ADDENDUM NUMBER ONE

**DARLA MOORE SCHOOL OF BUSINESS CONSTRUCTION – BP-2 STRUCTURE
UNIVERSITY OF SOUTH CAROLINA
STATE PROJECT NUMBER H27-6069-AC-2**

DATE OF ISSUE: January 12, 2012

SCALE :
1/8" = 1'-0"
SHEET NUMBER :
A-SK-006

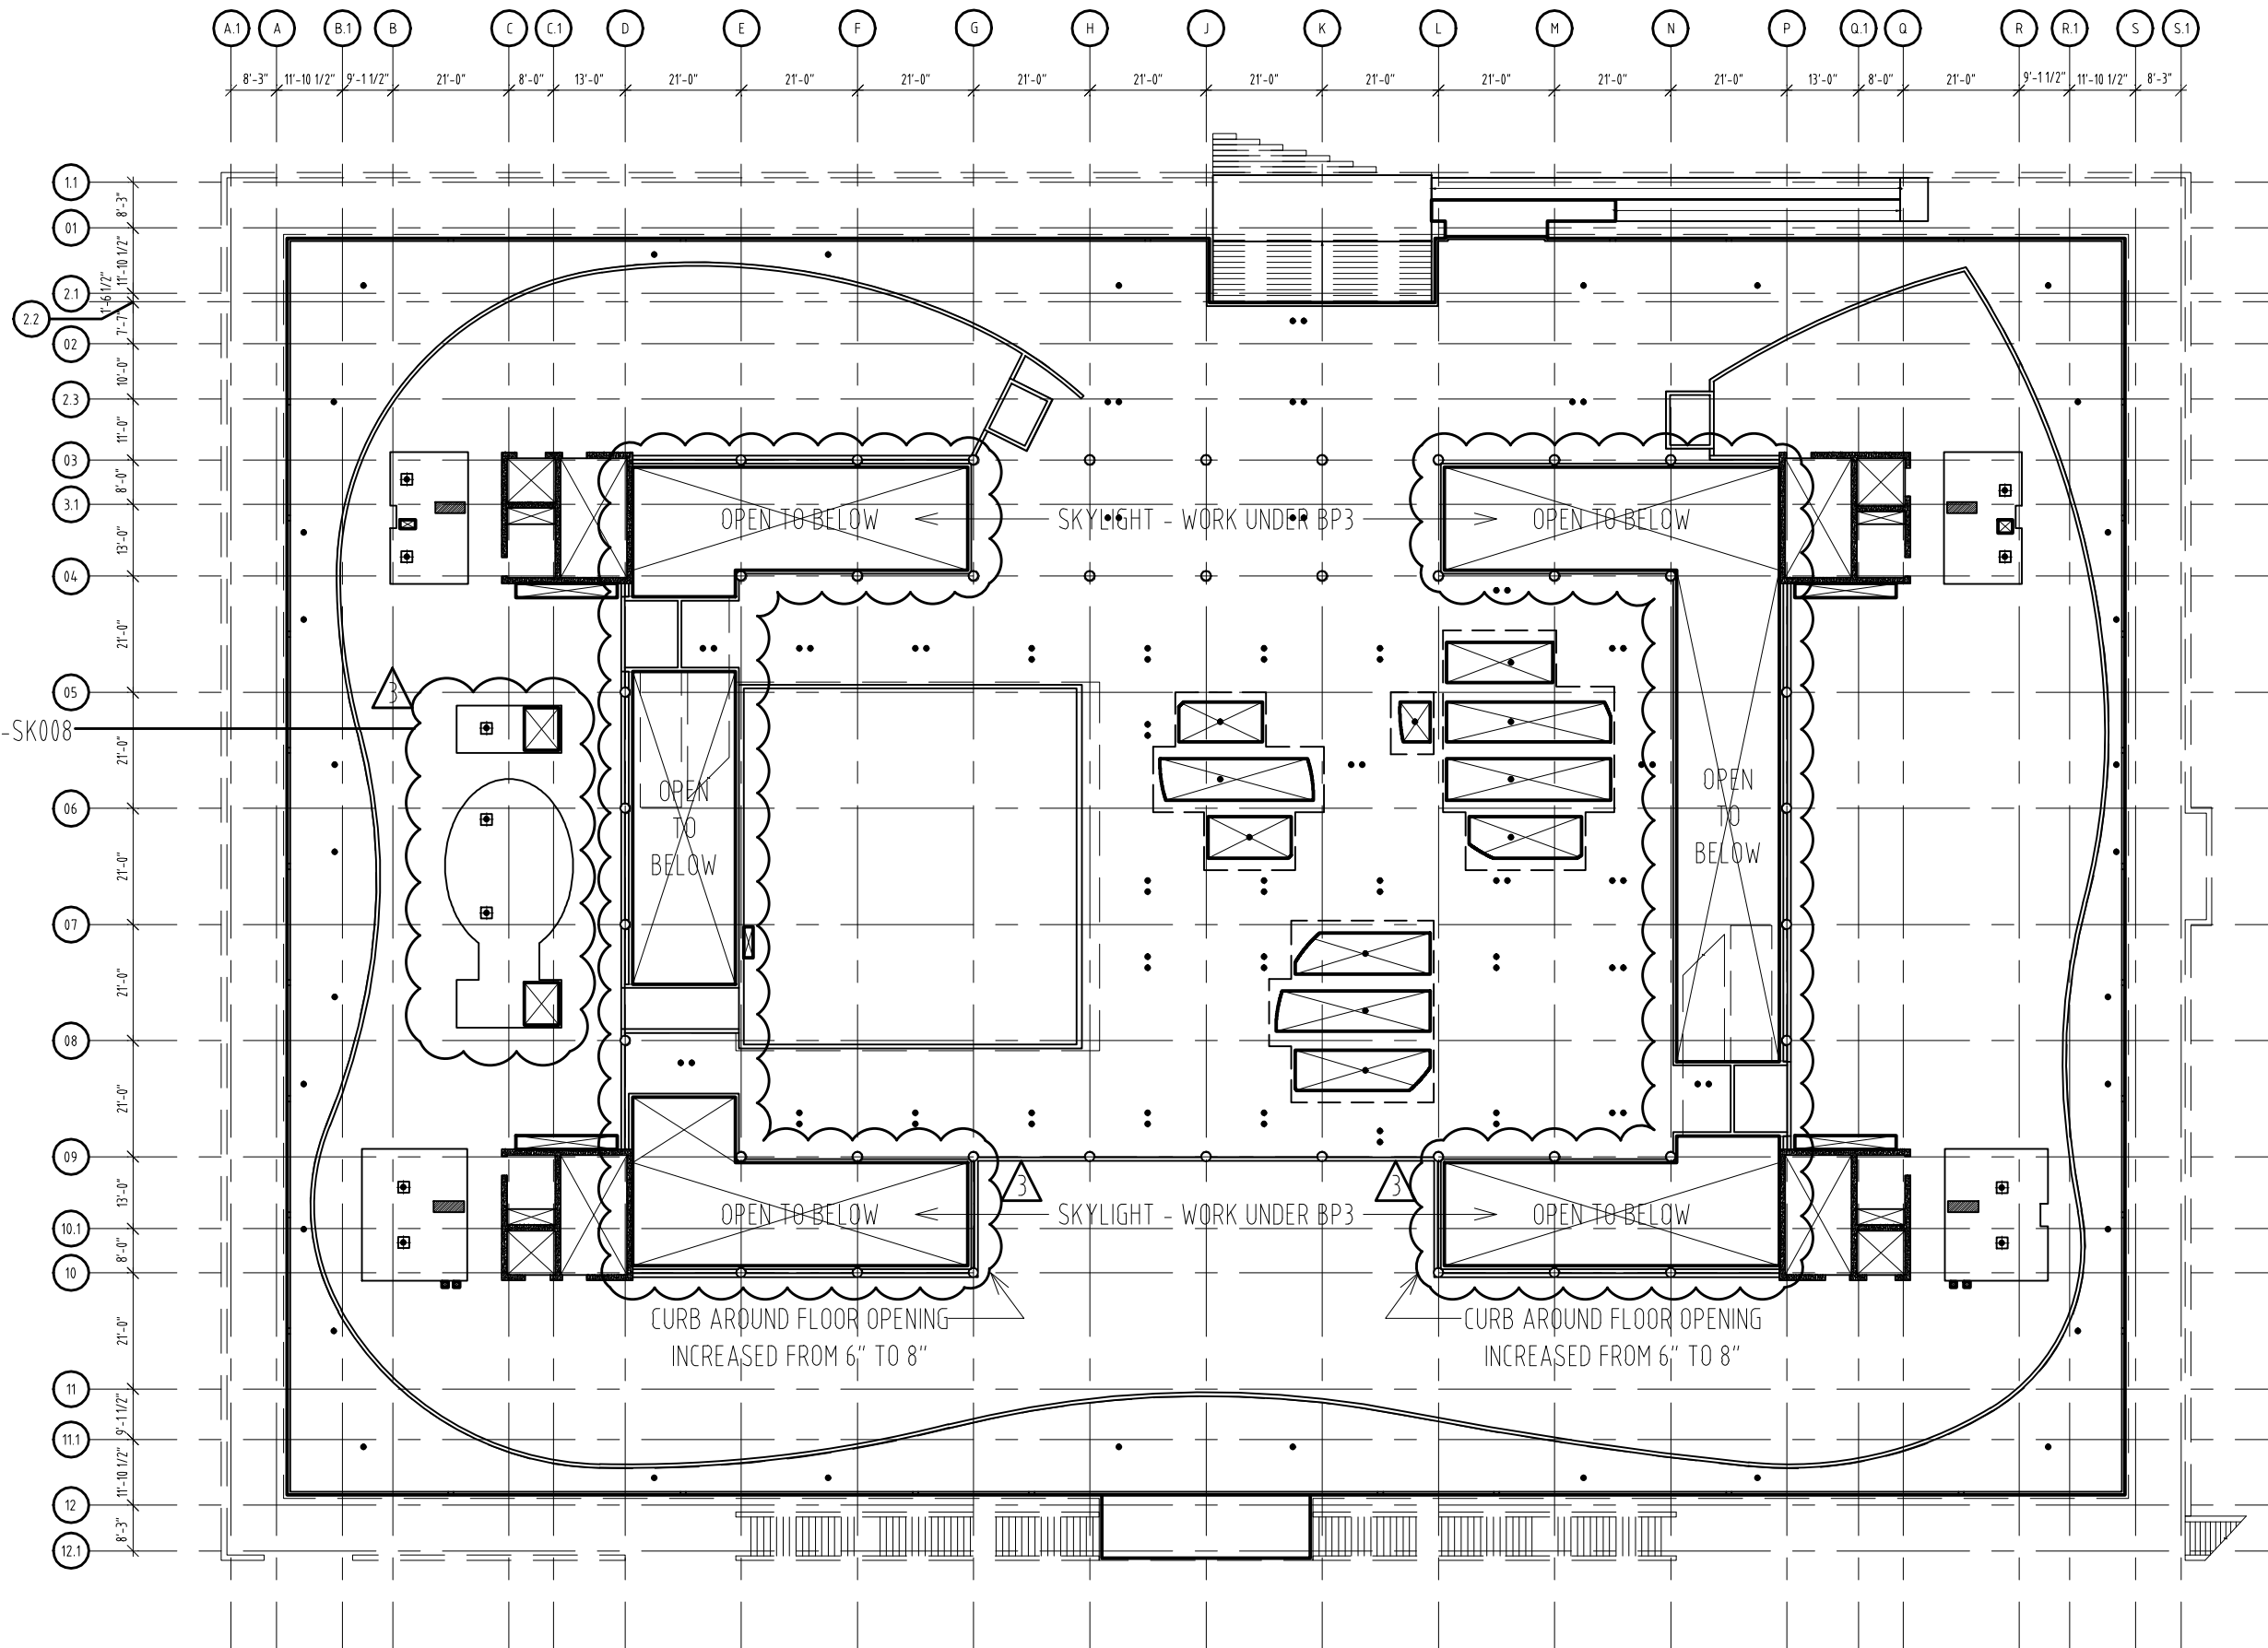
7.	Plan Sheet A1610, A1610D, A1610E: Refer to attached sketch A-SK-006 – Level 1 slab edge plans. Location of handrail post identified. Refer to sleeve detail 14/S2106 for slab on grade and detail 7/S4105 for elevated slabs. Revisions to Deep 'U' Case room 111 slab edge.

SCALE :
1/4" = 1'-0"
SHEET NUMBER :
A-SK-011

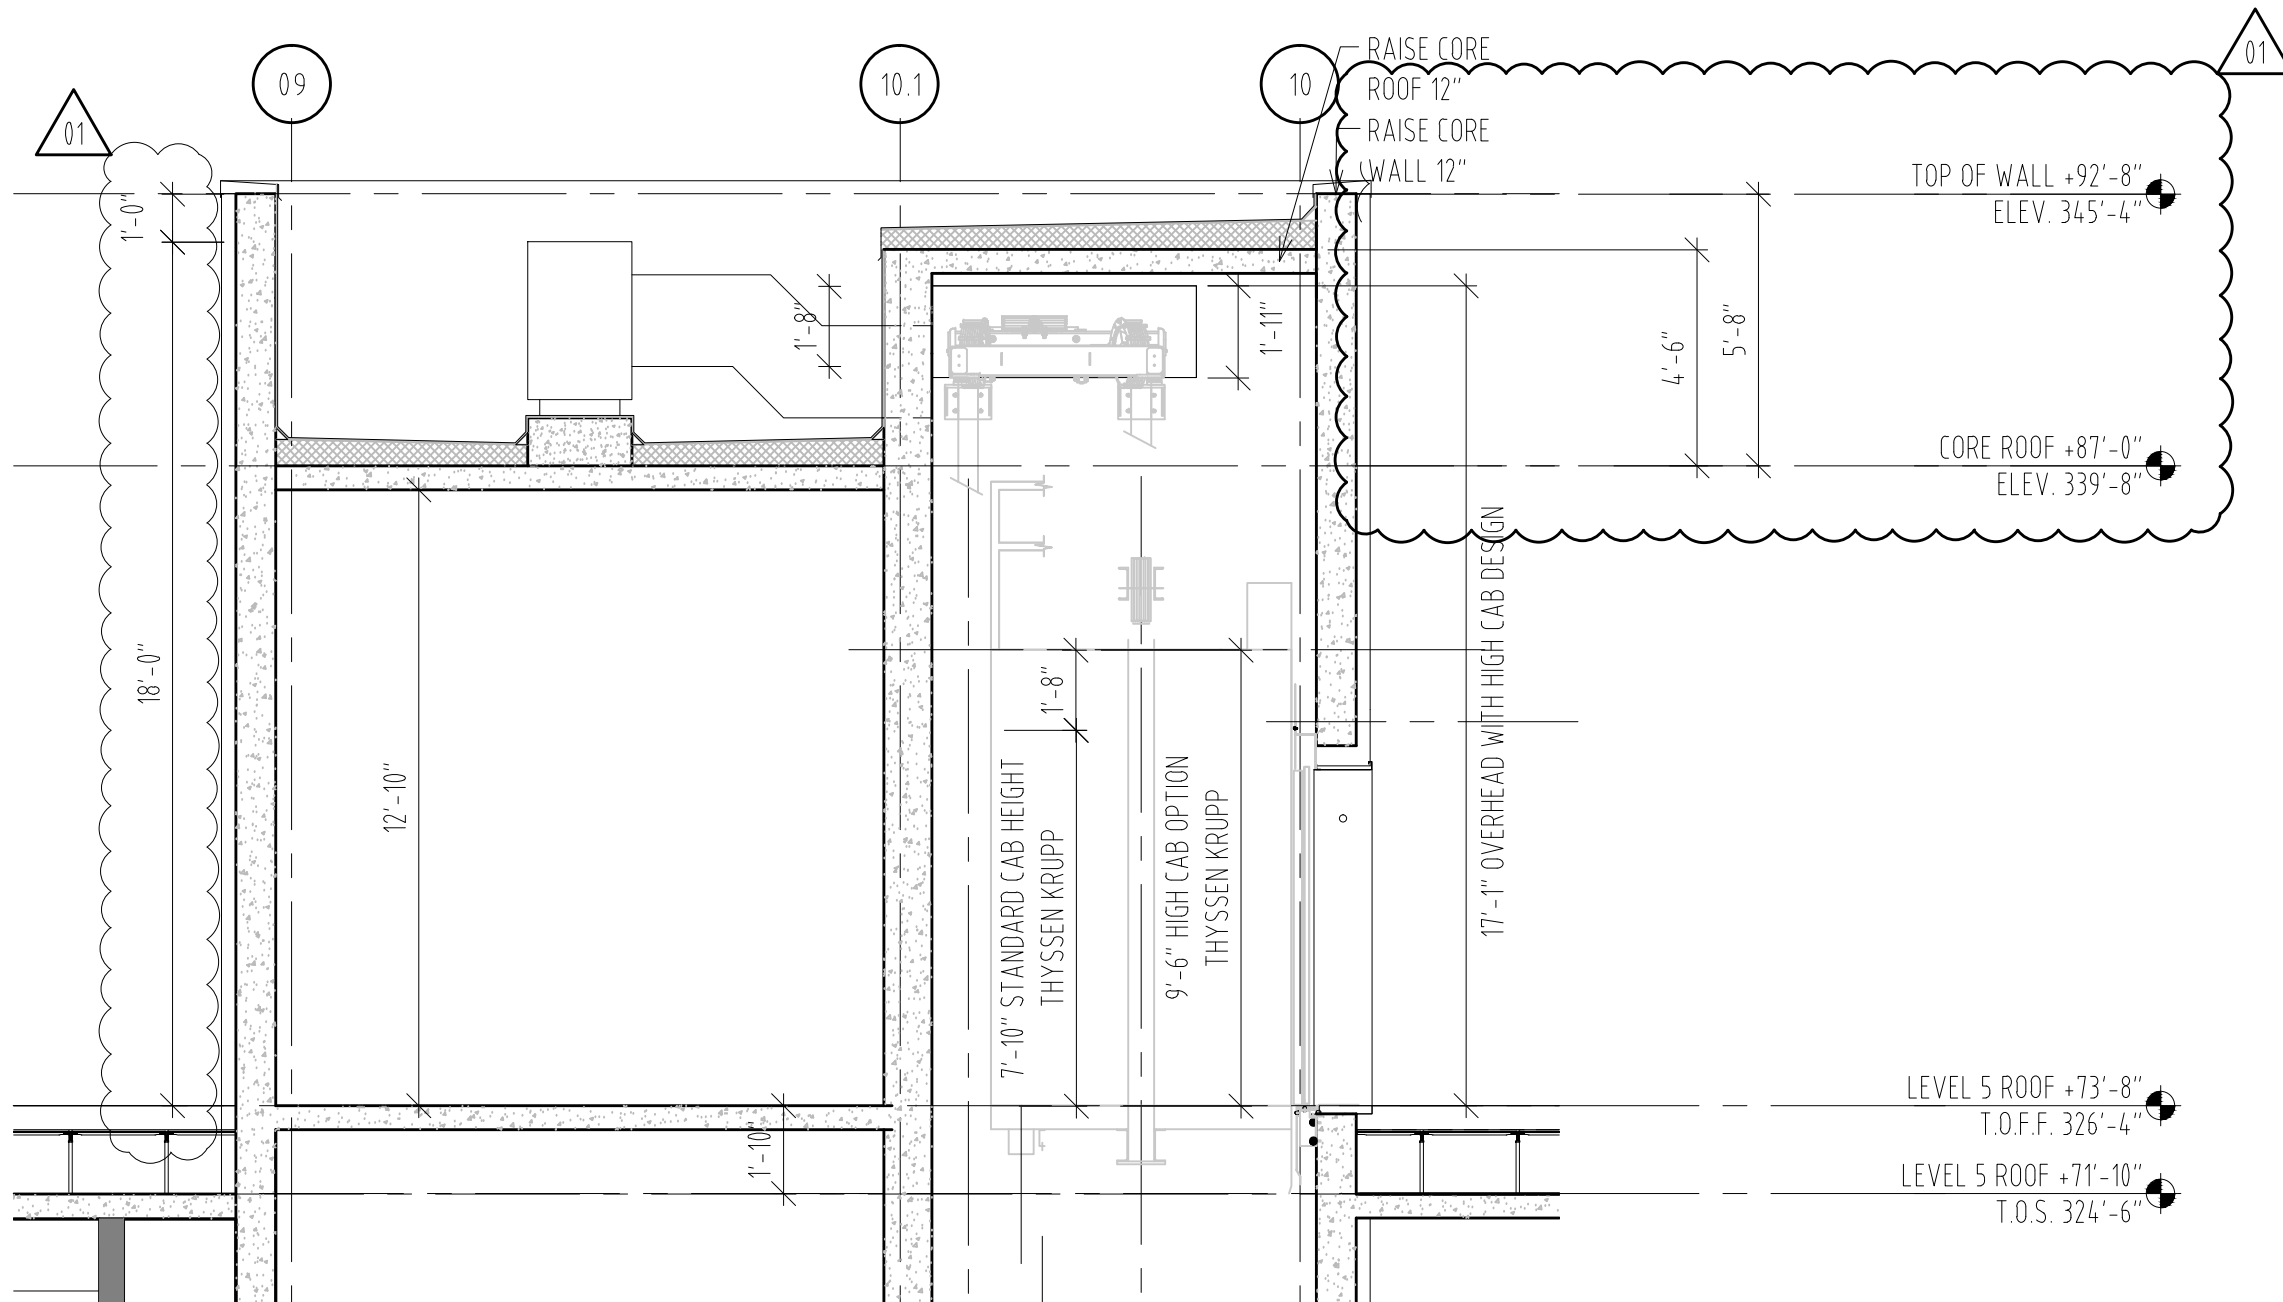
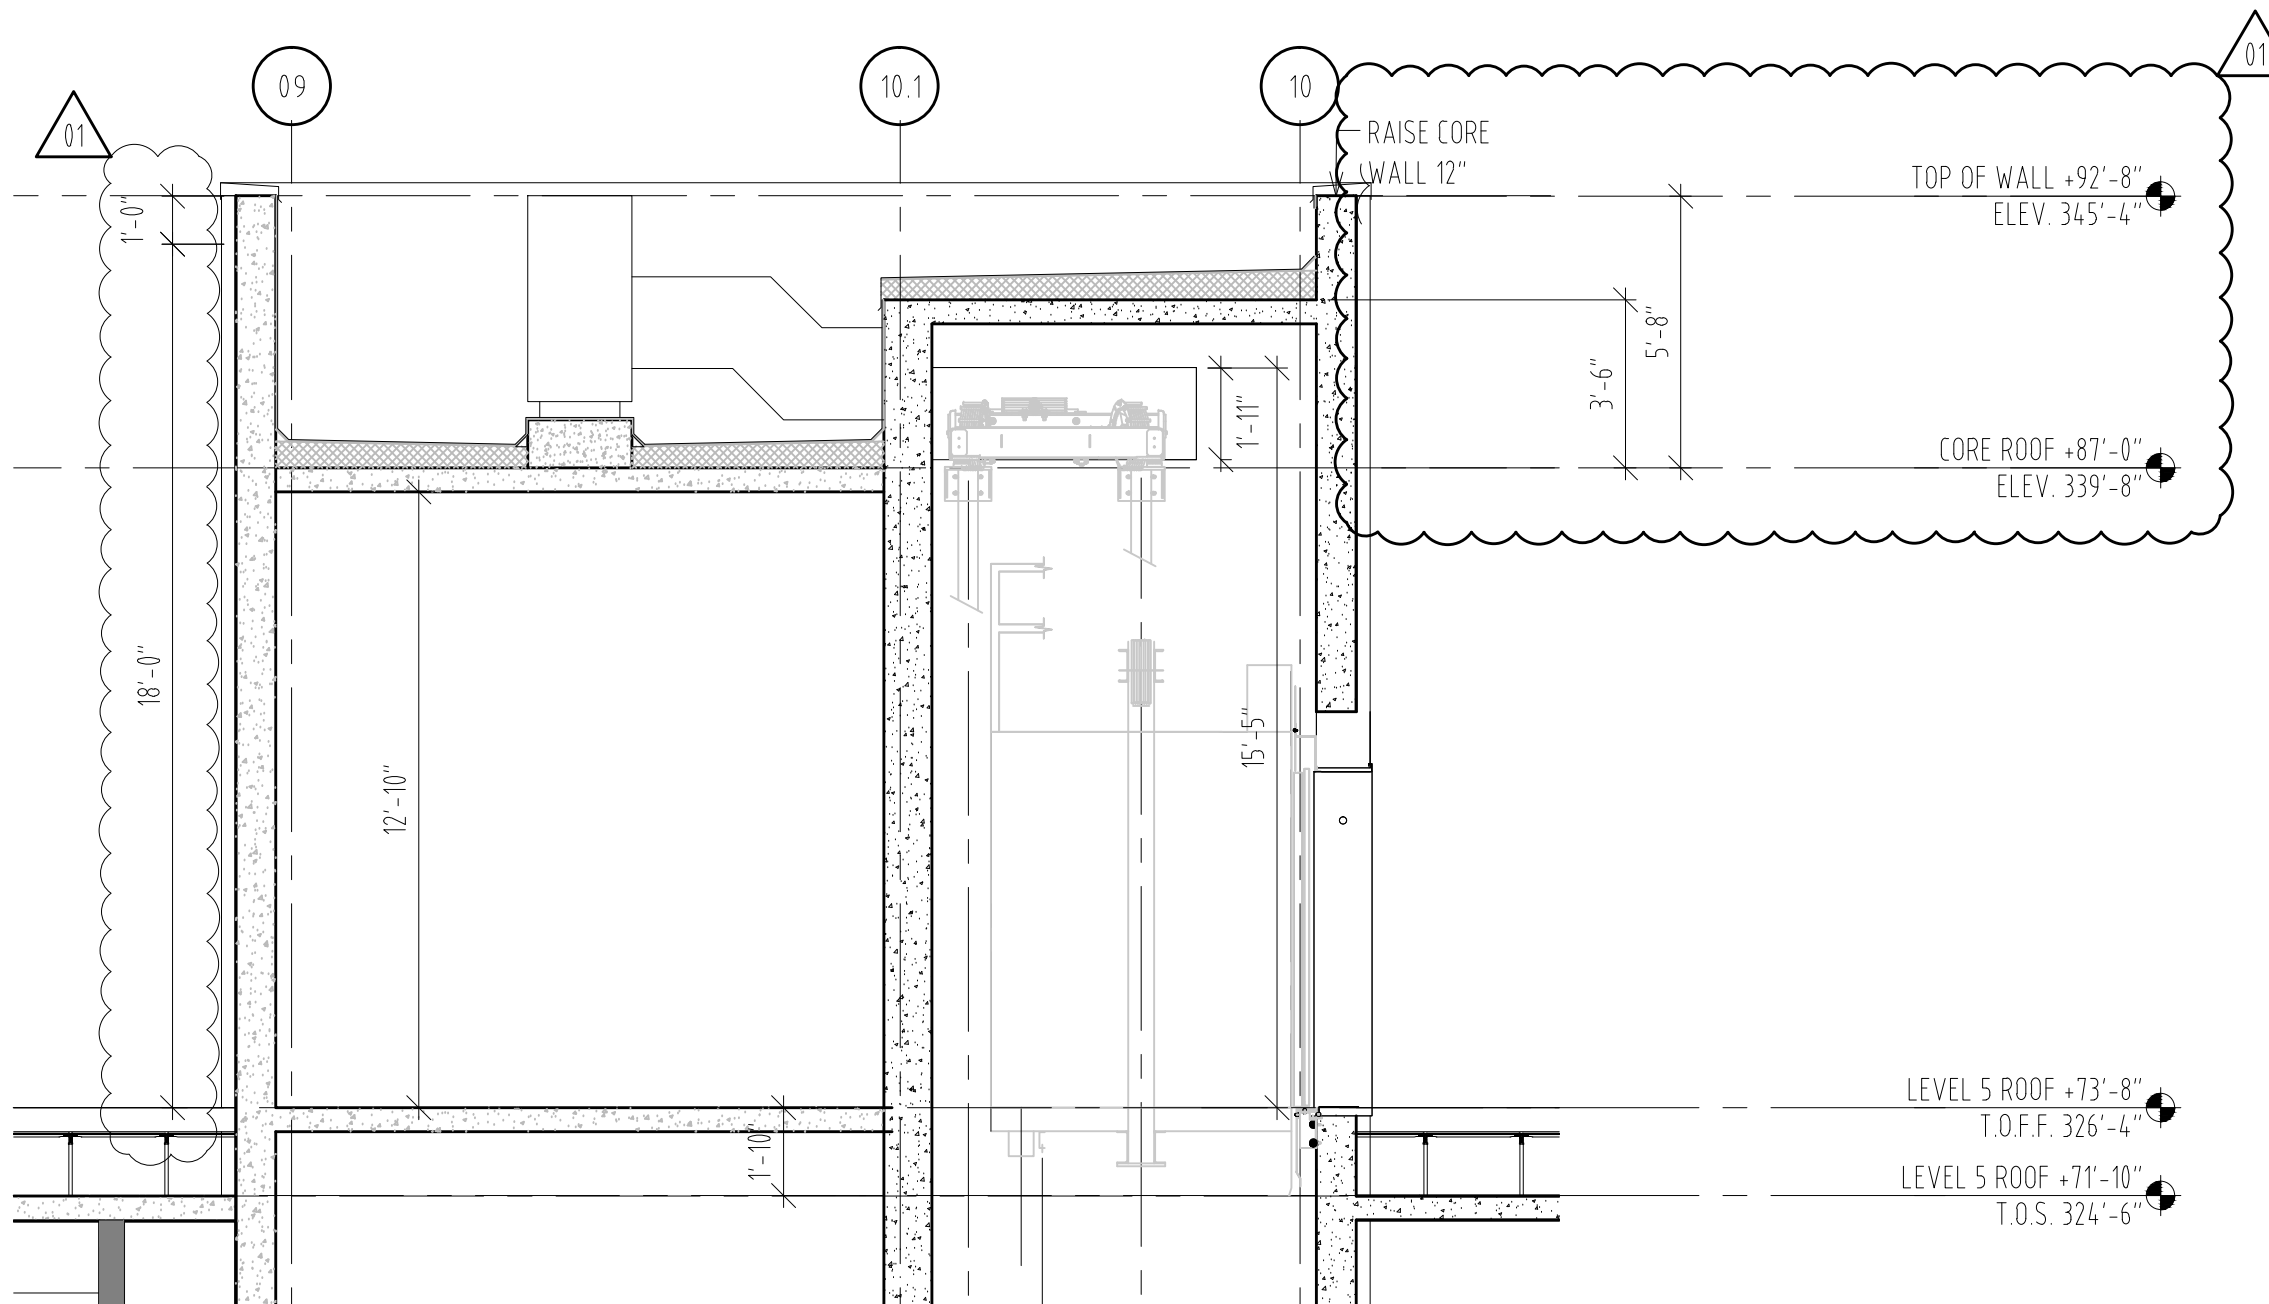
12.	Section sheet A4232: Refer to attached sketch A-SK-011 – section at core 3 Level 5 roof to core roof. Raise the elevator shaft roof and core perimeter wall by 1'-0".
